Metropolitan Historic Zoning Commission
Sunnyside in Sevier Park
3000 Granny White Pike
Nashville, Tennessee 37204
Telephone: (615) 862-7970

STAFF RECOMMENDATION
1906 Blair Boulevard
October 21, 2020

Application: New Construction—Infill
District: Belmont-Hillsboro Neighborhood Conservation Zoning Overlay
Council District: 18
Base Zoning: R6
Map and Parcel Number: 10416002100
Applicant: Will Jenner of Jenner Design, LLC
Project Lead: Sean Alexander, sean.alexander@nashville.gov

1920 Blair Boulevard. Thirty-two foot (32') wide structure on a fifty foot (50') wide lot.

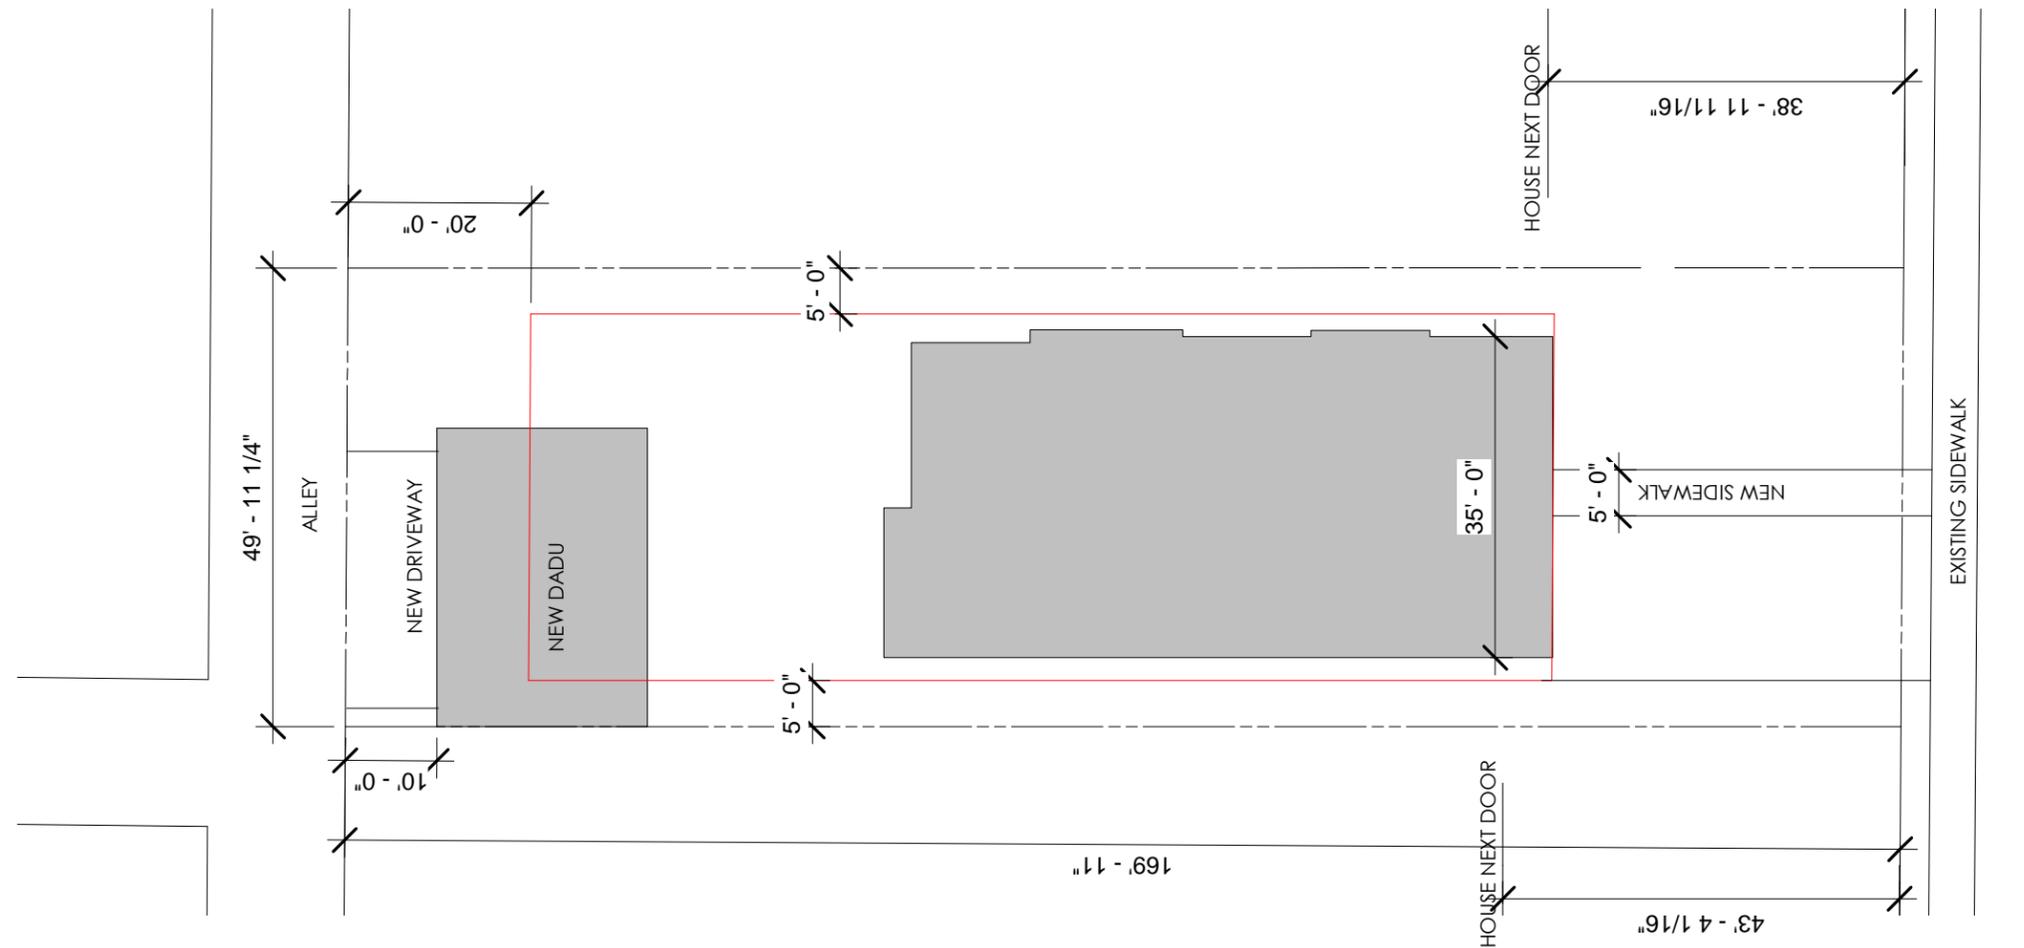
Nearby houses are thirty feet (30') and thirty-two feet (32') wide. The two-and-one-half-story house two lots to the left at 1916 Blair Boulevard is thirty-nine feet (39') wide, on a lot that is fifty-five feet (55') wide. Staff finds the width of the proposed house to be appropriate, within the range of historic buildings nearby.

Sheet Description:
ELEVATIONS

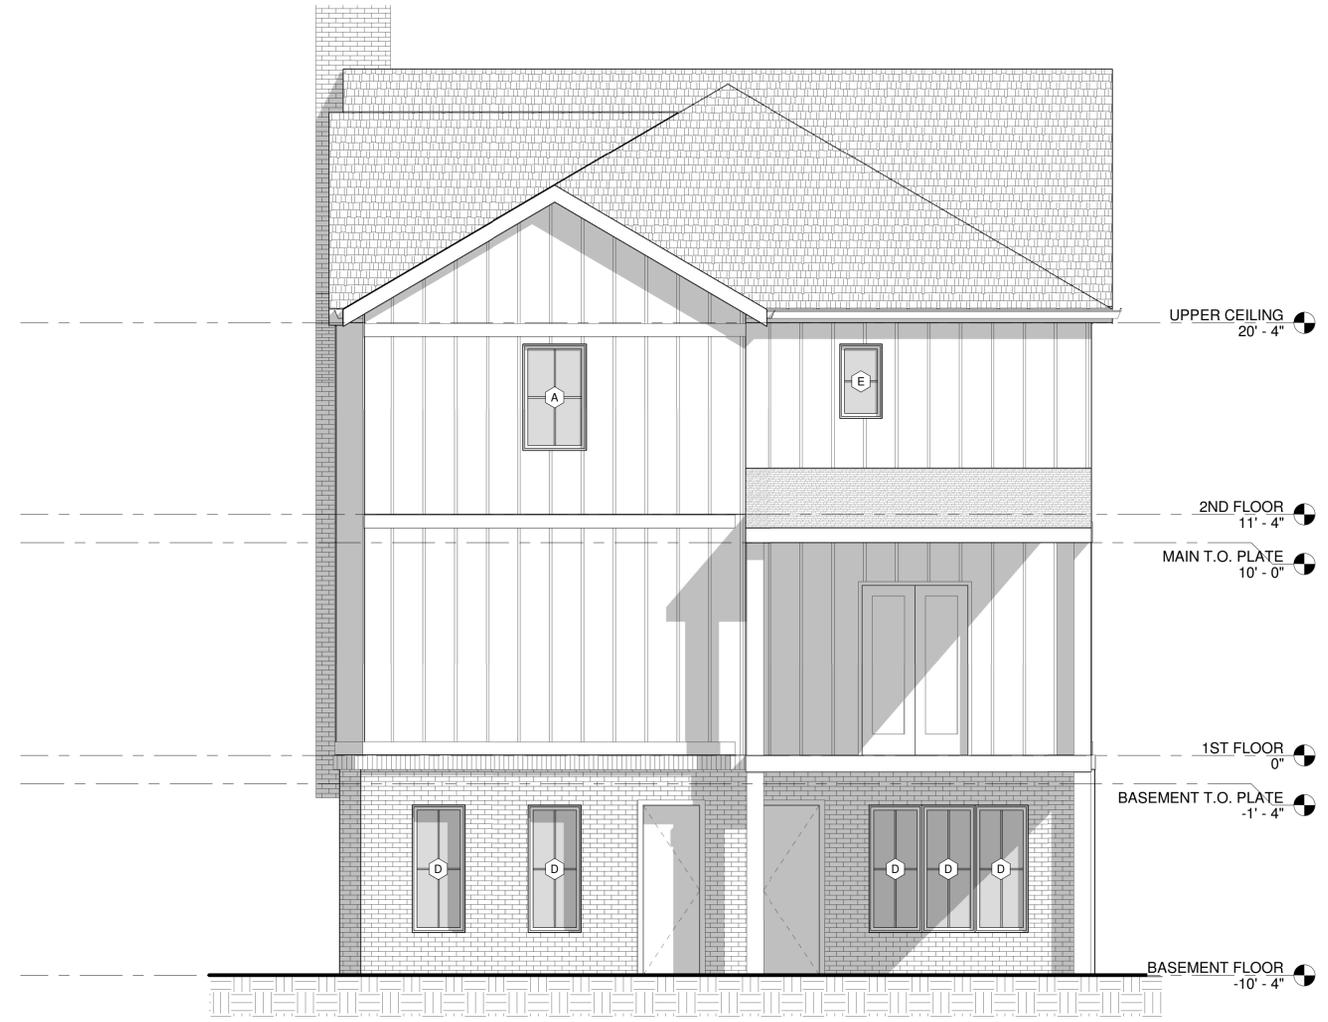
Height & Scale: The proposed new structure will have a two-story form with a height of thirty-three feet, six inches (33’-6”) from grade at the front, with an eave height of twenty feet, four inches (20’-4”) above the floor level and a one foot, four inch (1’-4”) tall foundation. The historic context includes one-and-one-half-story and two-and-one-half-story houses, ranging from twenty-two feet (22’) to thirty-six feet (36’) tall from grade. The structure will gain an additional story in the rear due to a significant drop in grade. This condition is typical of houses on similarly sloped lots. Staff finds the height of the proposed building will be compatible with the context.

Roof form: The roof of the new building will have a cross-gabled form with a pitch of 12/12 on the primary front and side-gabled components. The front elevation will have a projecting bay with a shed roof with a pitch of 8/12. The front porch will have a shed roof with a pitch of 3/12. These forms and pitches are consistent with the roofs of historic houses in the surrounding area.

Behind the side-gabled form, extending to the rear over the majority of the building, there will be a hipped roof a pitch of 7/12. This component will not be greatly visible from the right-of-way, and will not contrast greatly with the primary roof forms at the front of the building.

Proportion and Rhythm of Openings: The windows on the front and sides of the proposed infill are all generally twice as tall as they are wide, consistent with the proportions of openings on historic houses nearby. There are no large expanses of wall space without a window or door opening.

Staff finds that the proposal meets section II.B.1.d. of the guidelines, with conditions that the front porch columns shall be finished with capitals and bases, and that the roof color and the window and door selections shall be approved administratively.

1. The finished floor height shall be consistent with the finished floor heights of the adjacent historic houses, to be verified by MHZC staff in the field;
2. The front setback shall be consistent with the setbacks of the adjacent historic houses, to be verified by MHZC staff in the field;
3. The window and door selections and roof color shall be approved prior to purchase and construction;
4. The front porch columns shall be finished with capitals and bases; and,
5. The HVAC units shall be located on the rear of the building or on the side behind the midpoint.
